#### **ADDENDUM #3**

PROJECT: CODESTACK ACADEMY

REF. # : ARCH PROJ. No. 2023-04

DATE: 27 November 2024

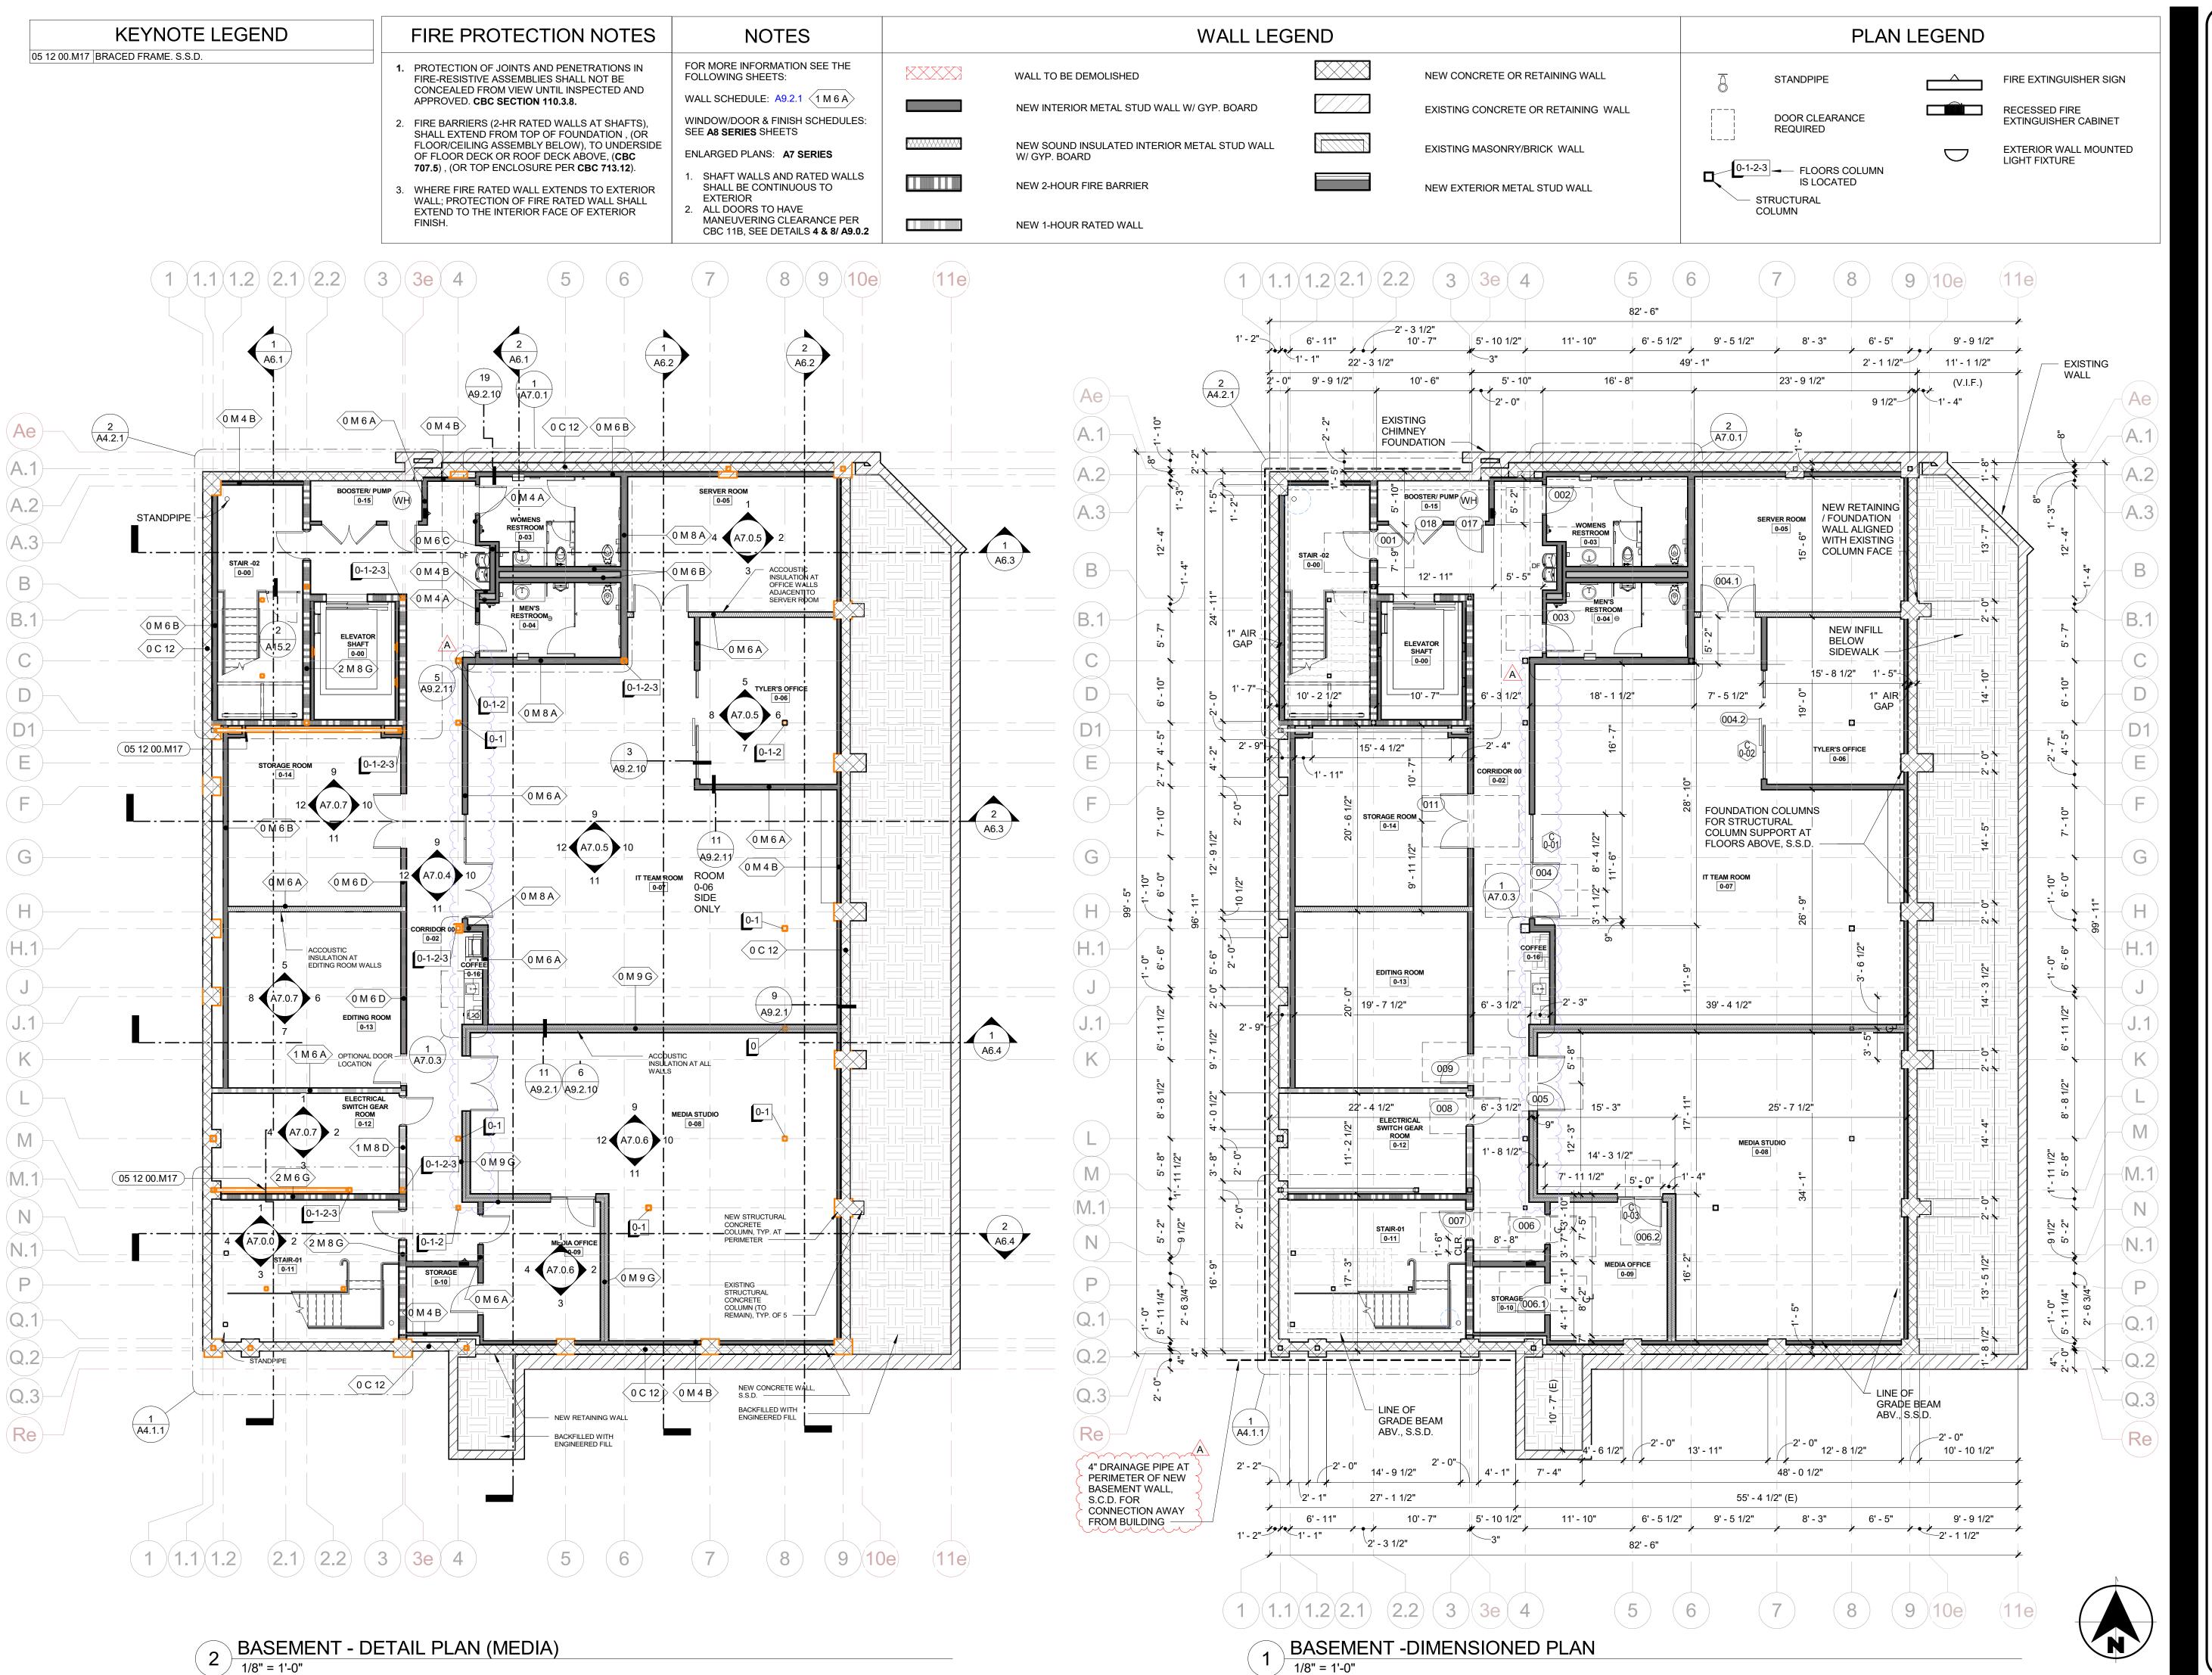
#### ITEM 1 <u>A2.1 - BASEMENT</u>

Wall on Grid (3), Grid (C-K) moved 9" toward east; coffee area sink/counter and printer flipped. Structural columns at Grid 3, increased.

#### ITEM 2 A2.1 – DRAINAGE PIPE

Added callout for drainage pipe at perimeter of new foundation walls at basement

A7.0.3

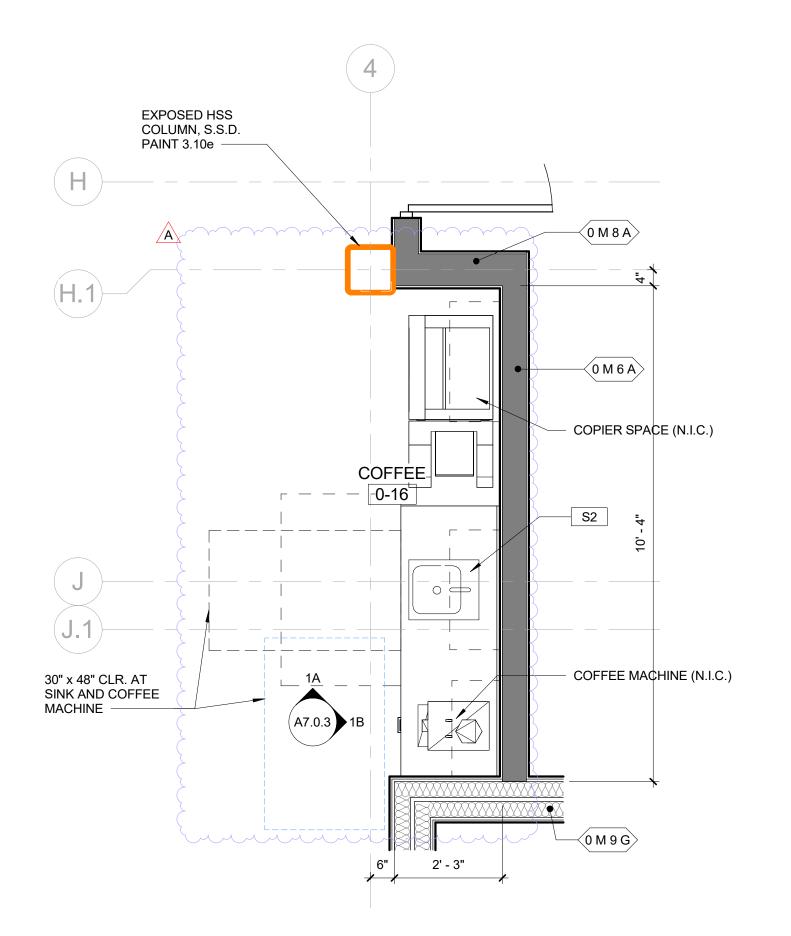
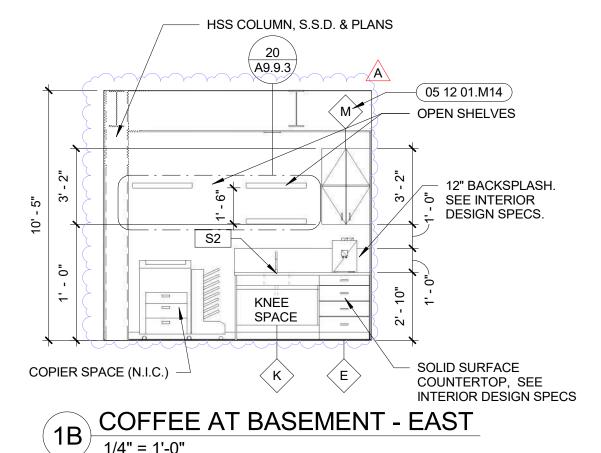
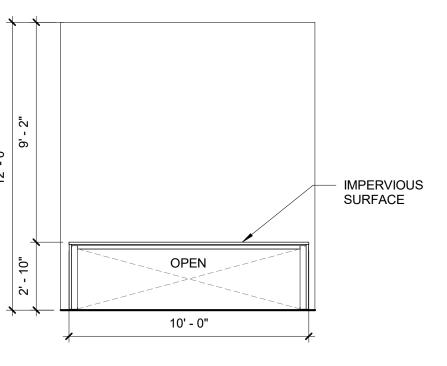
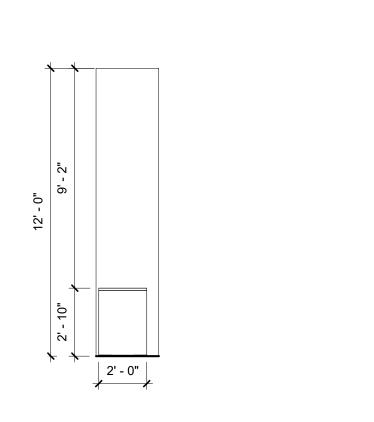
#### ITEM 3 A7.03 - COFFEE

Due to Structural columns at Grid 3, increasing, coffee area sink/counter and printer flipped.
